**CITY OF BLOOMINGTON**

**CITY OF BLOOMINGTON  
PLAN COMMISSION  
August 10, 2015 @ 5:30 p.m.**

**BLOOMINGTON PLAN COMMISSION  
STAFF REPORT – SECOND HEARING  
Location: 2300 S. Walnut Street**

**CASE #: SP-15-15  
DATE: August 10, 2015**

SHEET NAME  
**EXTERIOR ELEVATIONS**

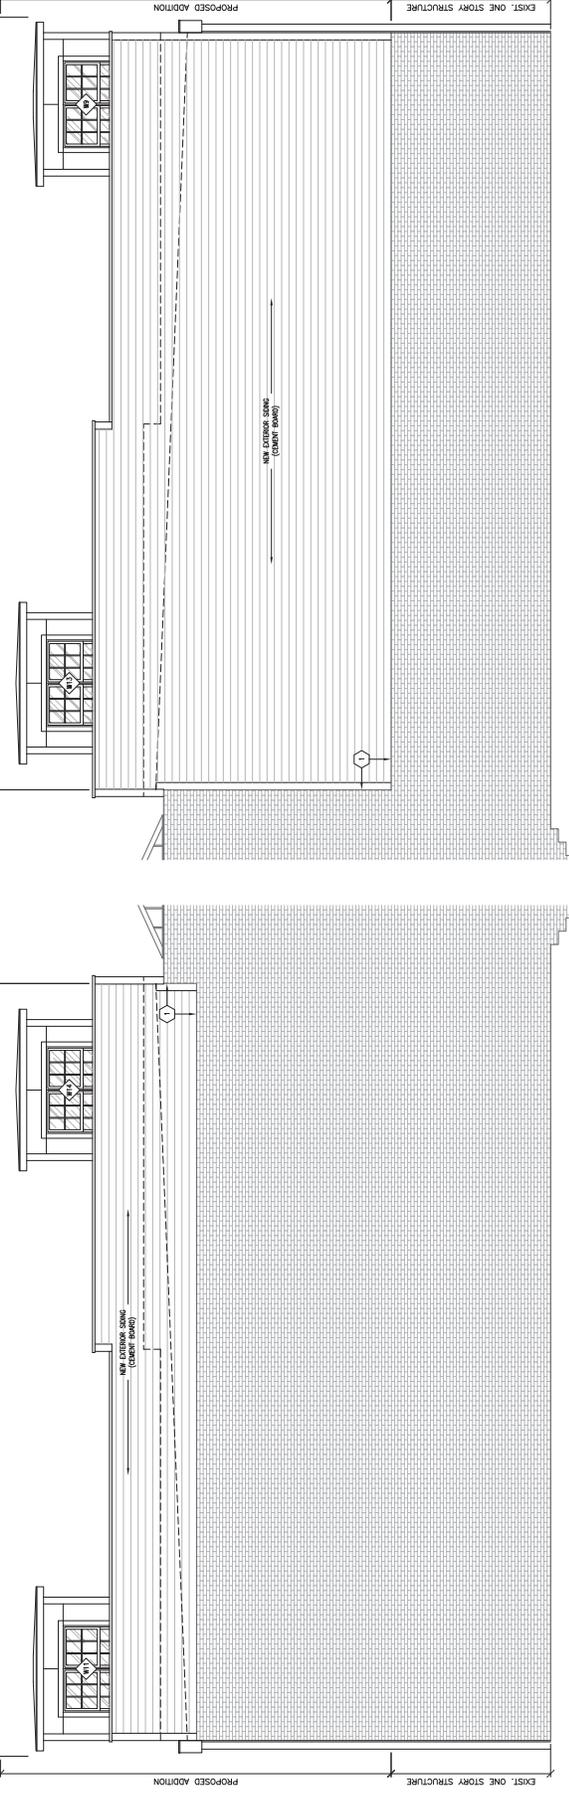
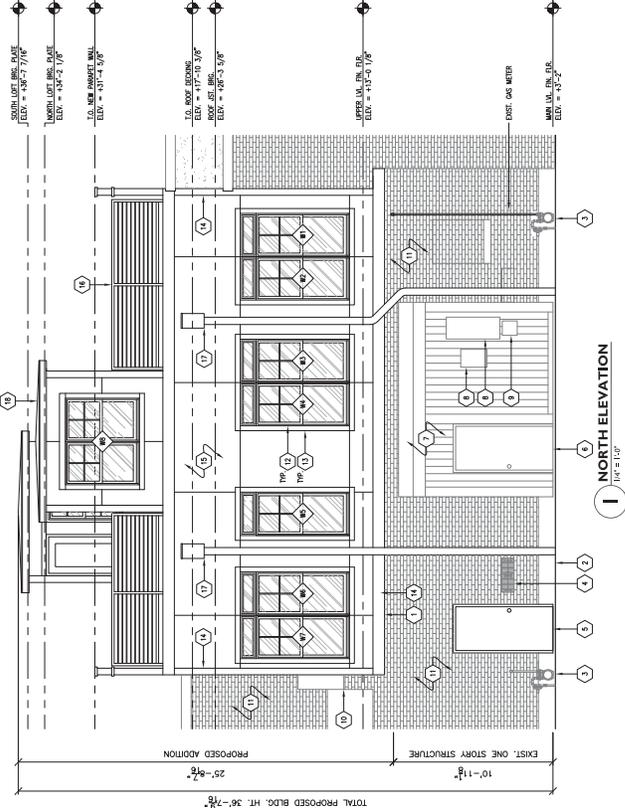
**Material Waiver-20.03.060(b)(4):** A waiver from the standards of the UDO is required to allow cementitious panels and cementitious siding as an exterior finish material. The Downtown Plan provides guidance on building materials in Guidelines 3.10 through 3.12. Guideline 3.10 states that materials should appear similar to those used traditionally and that masonry is preferred for new construction. Guideline 3.11 states that “new materials may be considered” as long as they appear similar to traditional materials, are detailed to express human scale, have demonstrated durability, and avoid large expanses of featureless siding. Planning staff has determined that the panels are appropriate in this area, where they are not visible from the street or the Courthouse Square, and recommends approval of this waiver.
